ASSESSMENT REPORT

DARGUES REEF GOLD PROJECT Section 75W Modification MP 10_0054 Mod 1 – Paste Fill

Figure 4: Predicted Recovery of Groundwater Levels

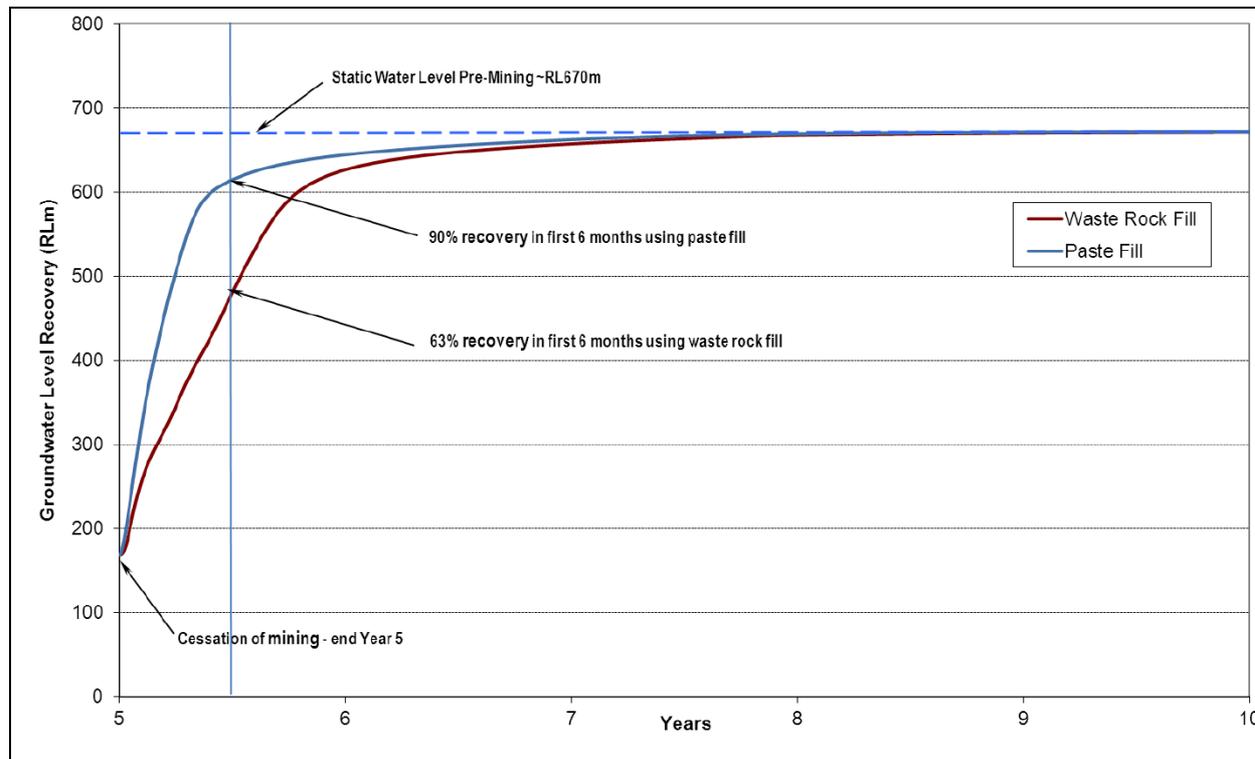
As illustrated in **Figure 4**, AGE predicts that groundwater levels would initially recover to 90% of pre-mining levels within 6 months of the cessation of mining, compared to 63% during the same period for the approved project (i.e. with rock-filled stopes and voids). This will result in:

- groundwater levels in landowner bores recovering at a faster rate; and
- a faster stabilisation in groundwater discharge to Spring and Majors Creeks.

This may also have the advantage of enabling BIM to scale back or cease its compensatory flow program earlier than would otherwise be the case with the approved project.
